Enclosure C
ULNRC- 941

MARKED TECHNICAL SPECIFICATION PAGES

ADMINISTRATIVE CONTROLS

FIGURE 6.2-2
UNIT ORGANIZATION

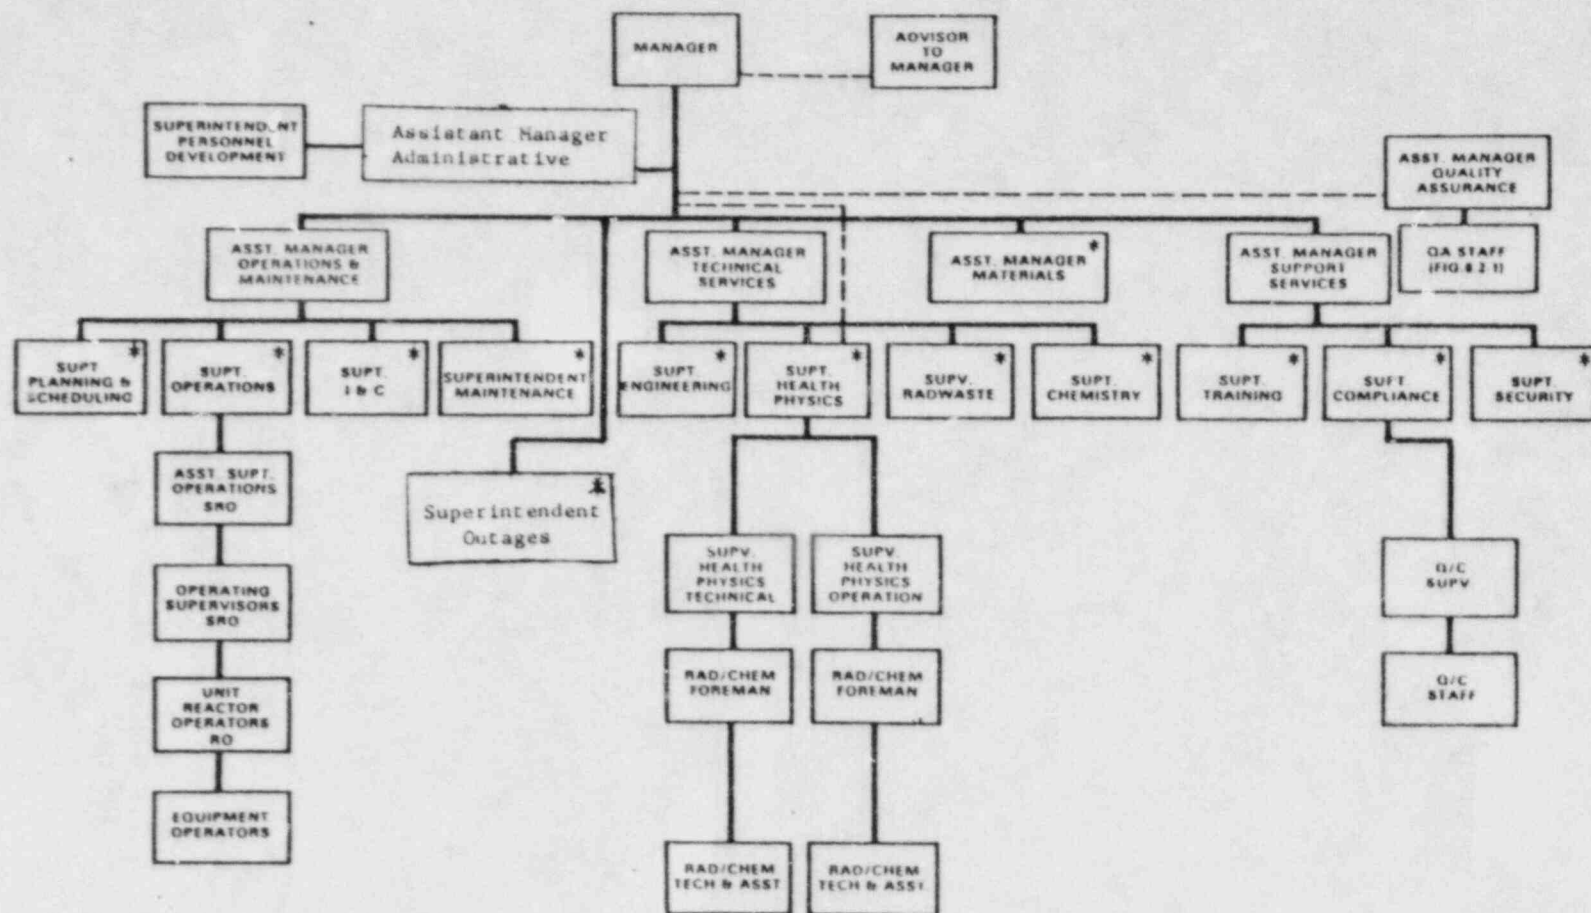
Chairman:	Manager, Callaway Plant
Member:	Asst Mgr, Oper and Maintenance
Member:	Asst Mgr, Tech Services
Member:	Asst Mgr, Support Services
Member:	Supt, Health Physics
Member:	Supv Eng, Quality Assurance
*Member:	Adv to Mgr, Callaway Plant
Member:	<i>Asst Mgr, Administrative</i>

*This member may be removed when this position is abolished.
